**Minutes of the Regular Telephonic Meeting of the Albany County Airport Authority**

**April 6, 2020**

**11.1 Change Orders #5 & 6: Authorization to award Change Orders No. 5 & 6 to Contract No. 989-GCr New Parking Garage General Construction to LeChase Construction Services, LLC.**

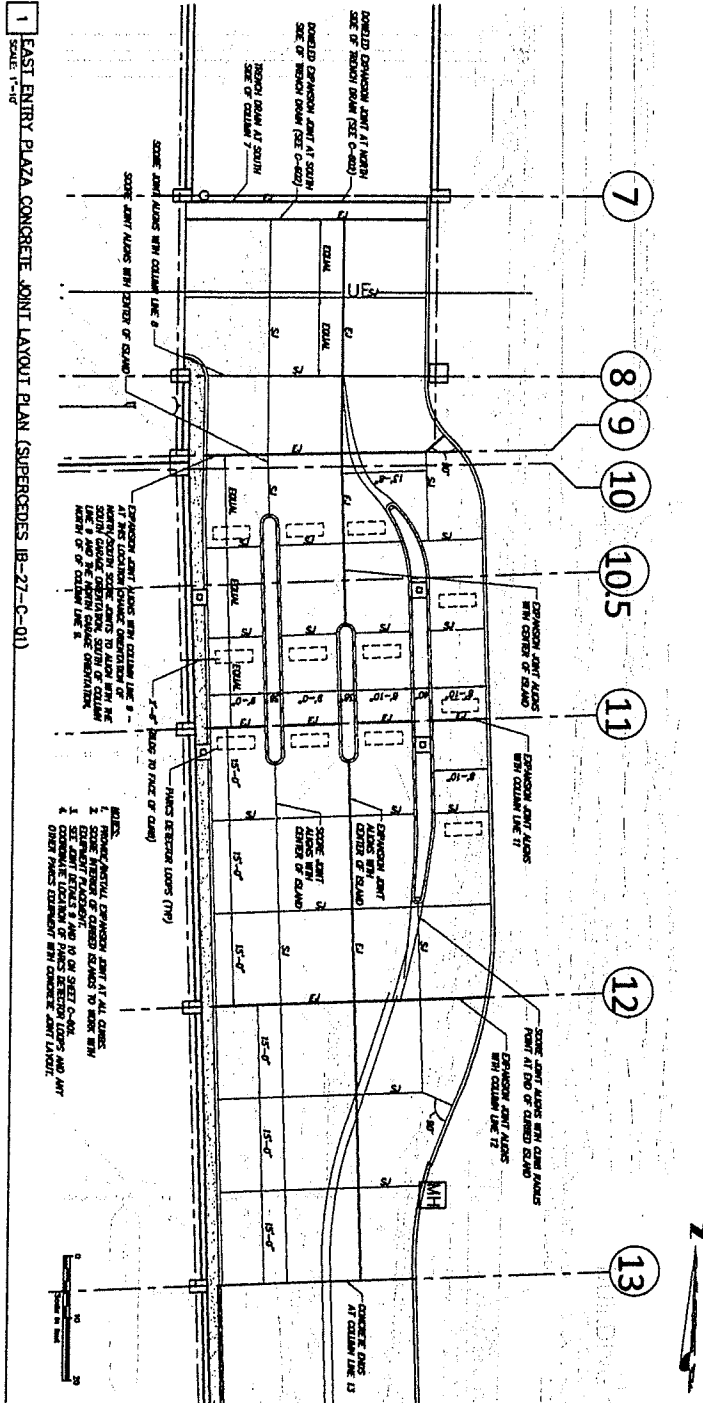
Coordinate location of PARCS system loop detectors and any other PARCS equipment with concrete joint locations. See the attached drawing IB27-C-01.

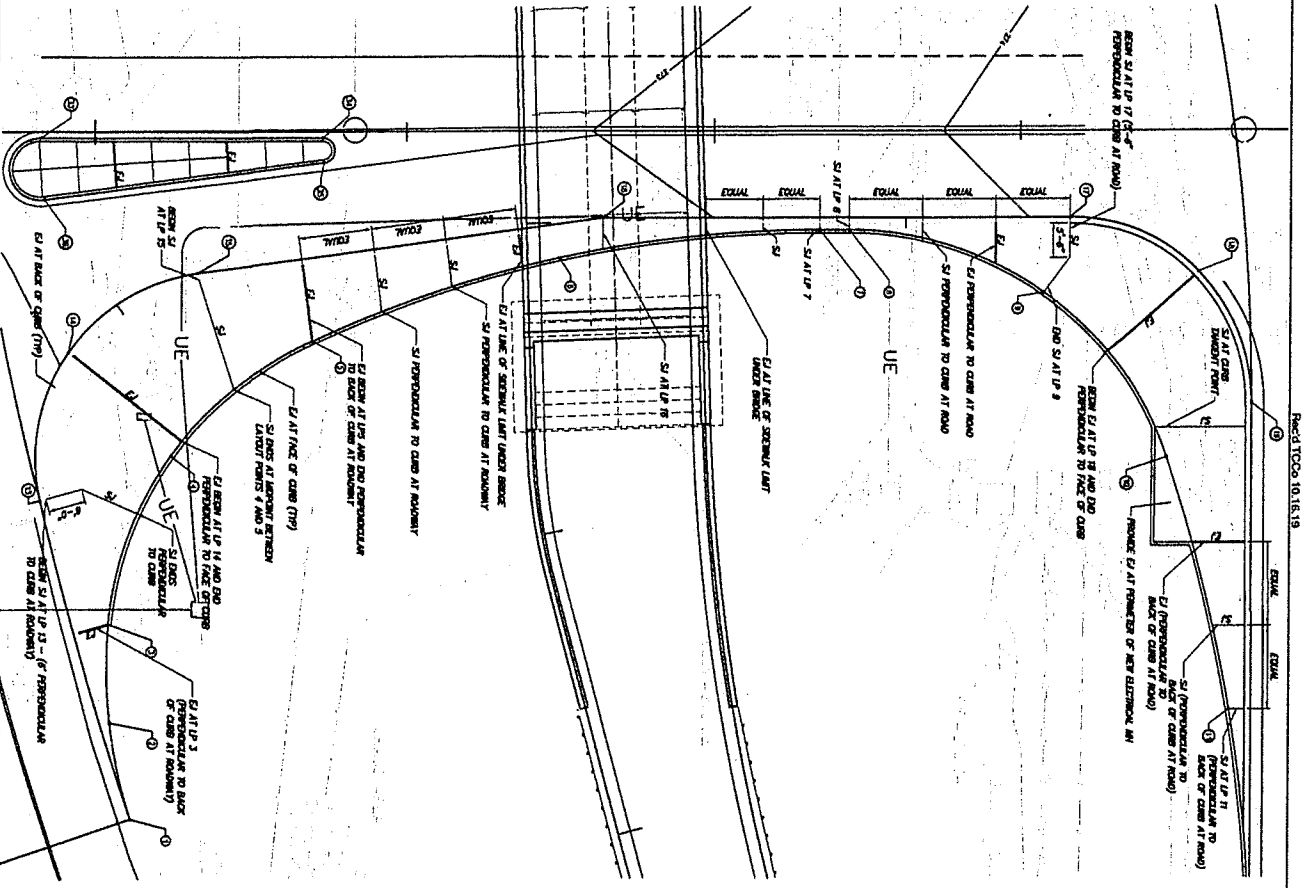
See attached drawing IB-28-C-01 for the joint layout for the stamped concrete along the south side of Jetway Drive.

Provide labor and material to install the clarification of the layout of joints along Jetway Drive per updated drawing 1B-28-C-01 for joints in stamped concrete on south side of Jetway Drive

# 2ND LEVEL

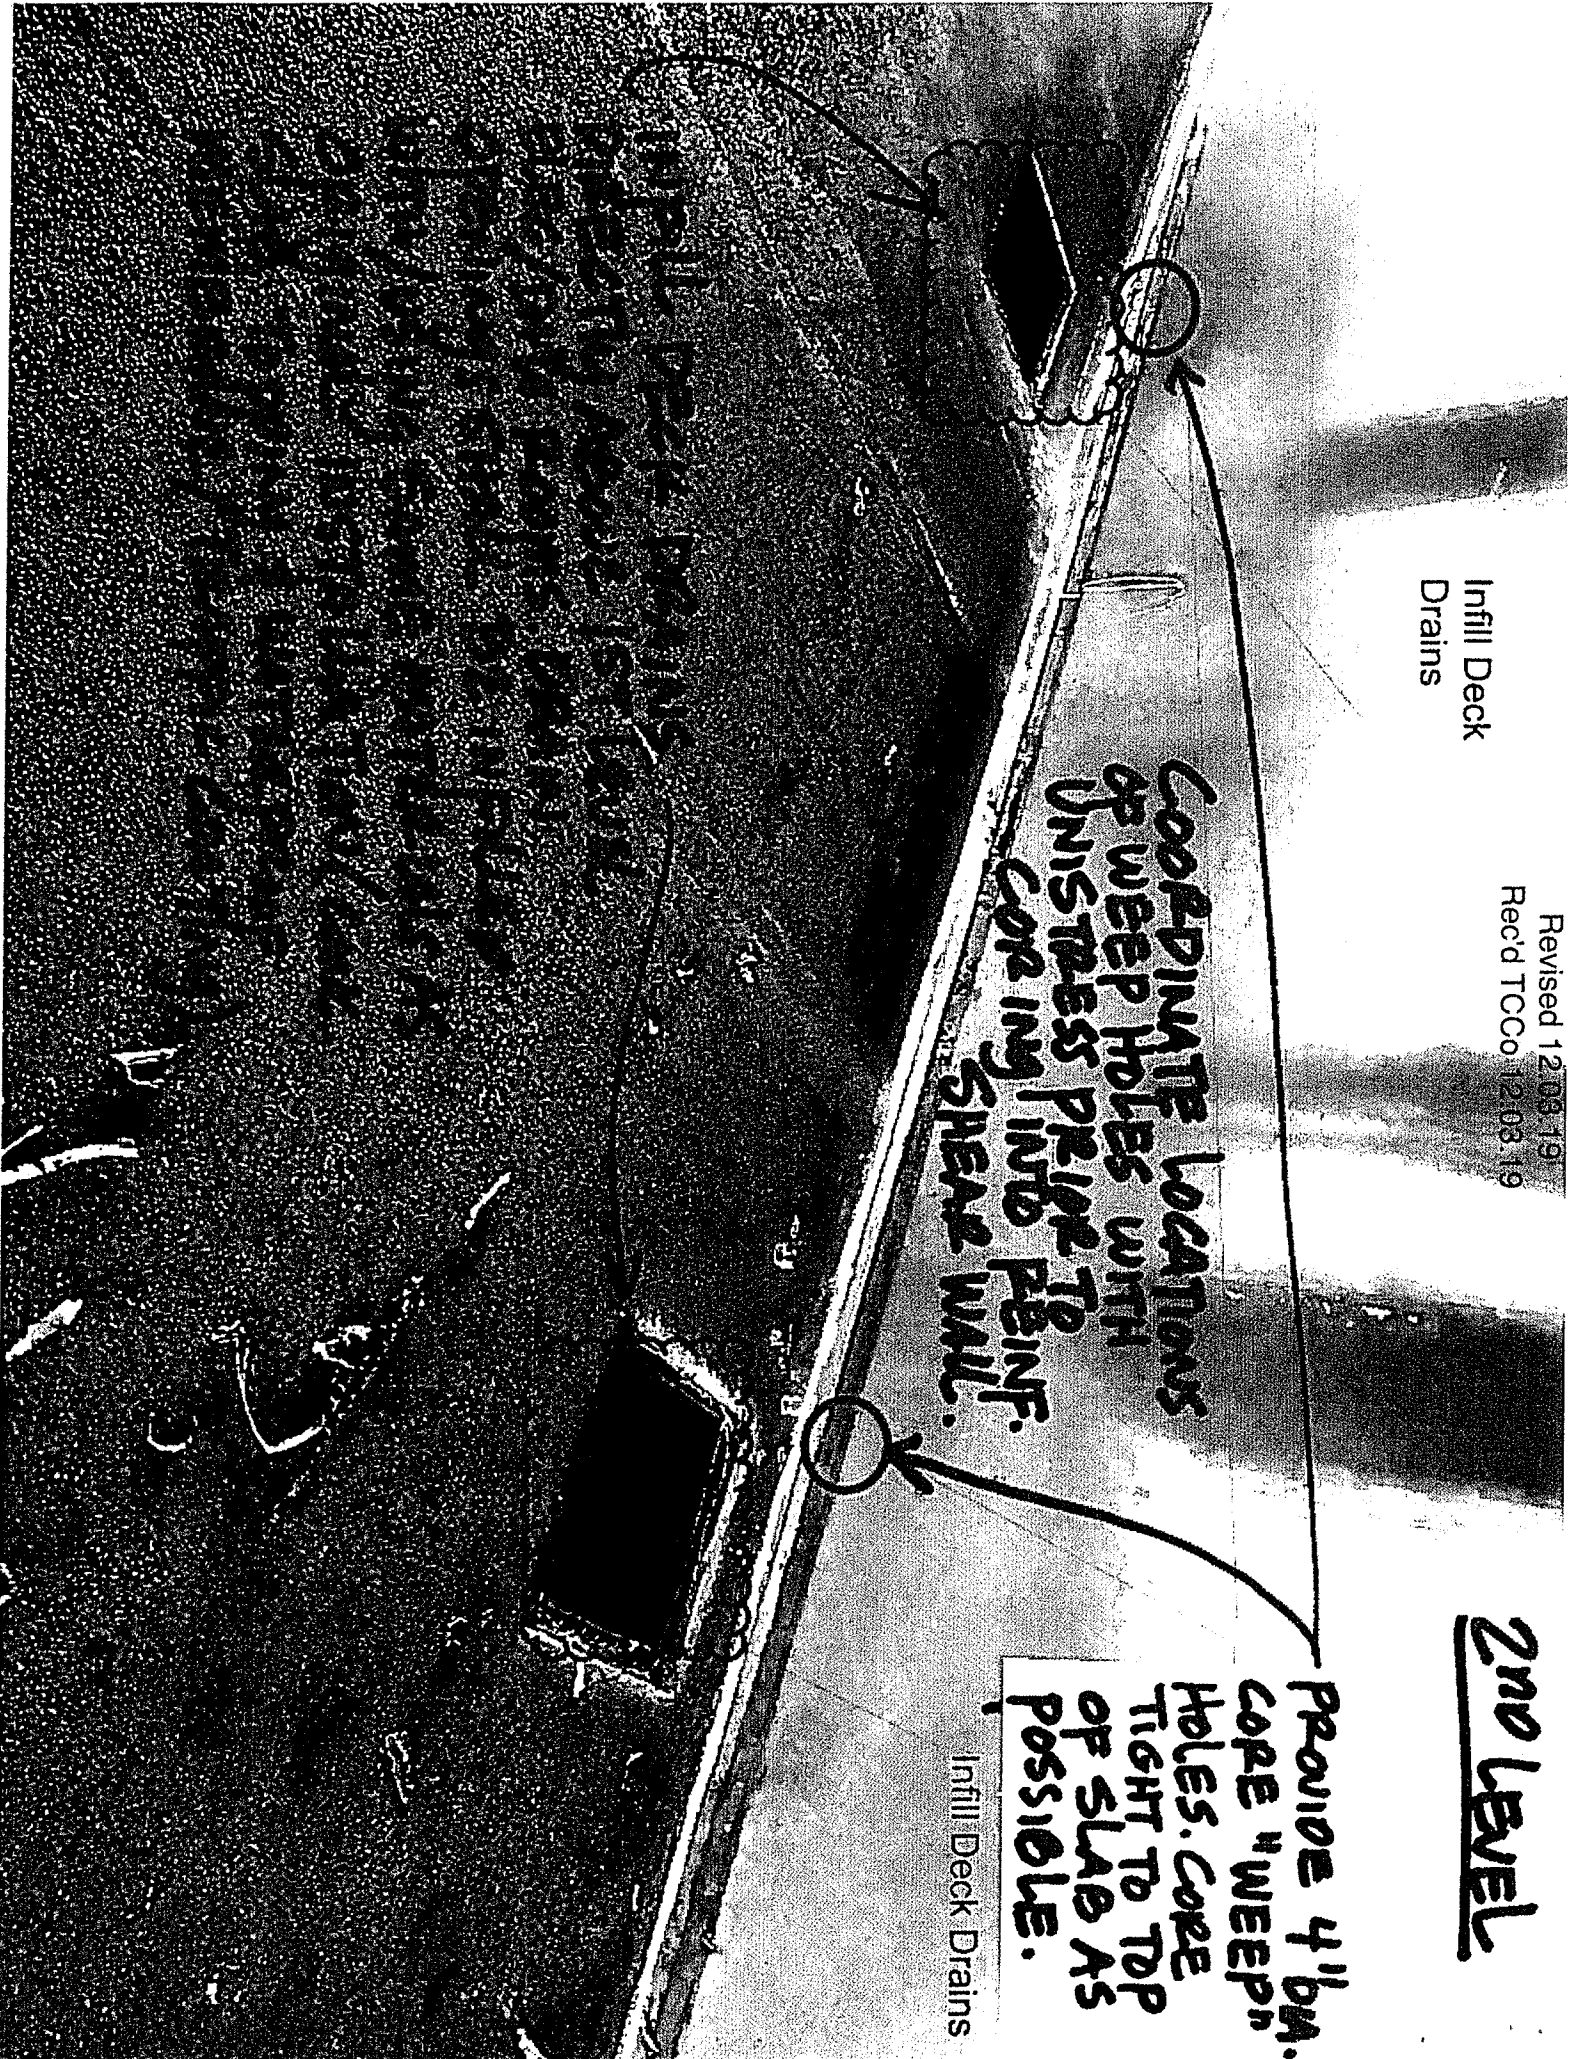
PROVIDE 4" DIA.  
CORE "WEEP"  
HOLES. CORE  
TIGHT TO TOP  
OF SLAB AS  
POSSIBLE.

**RFI # 265 modifications**

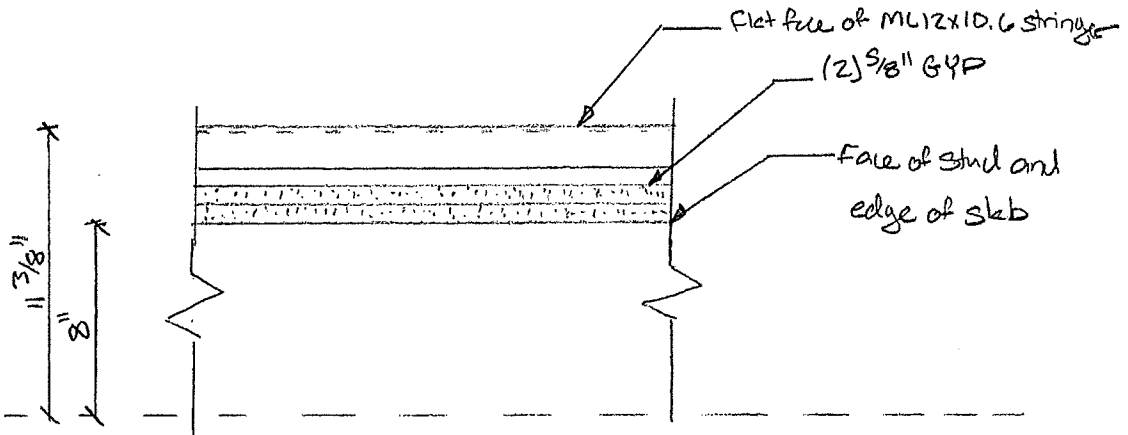
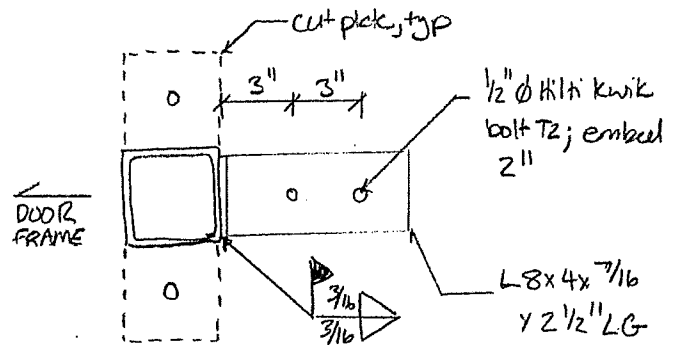
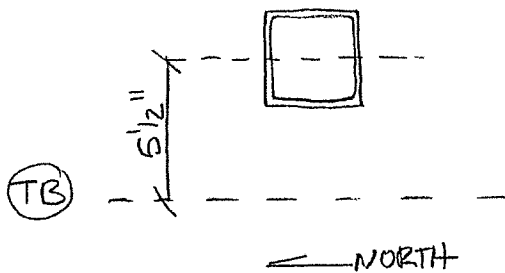
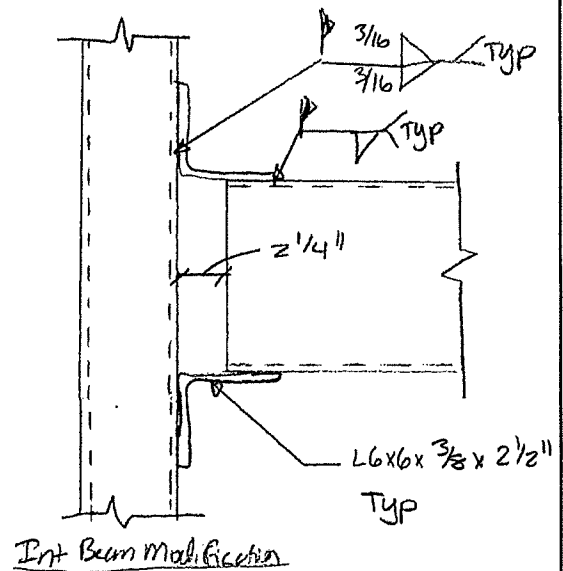
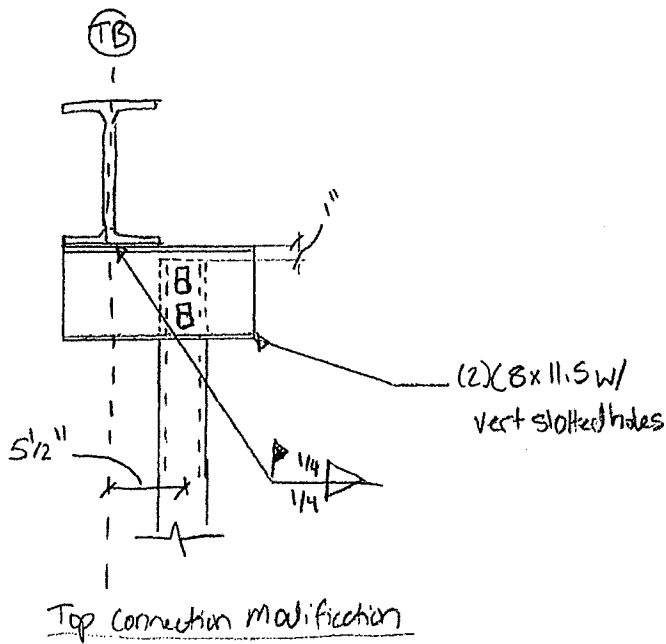
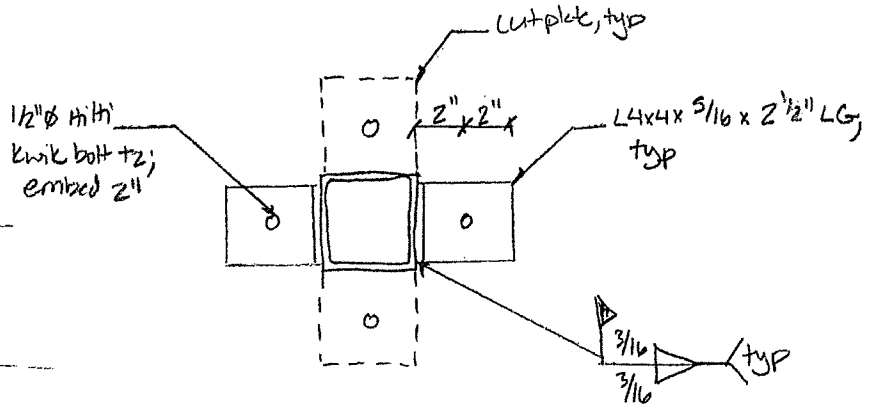
East Shaft well modifications

West Shaft well modifications

column IC3 modifications

column IC1 modifications
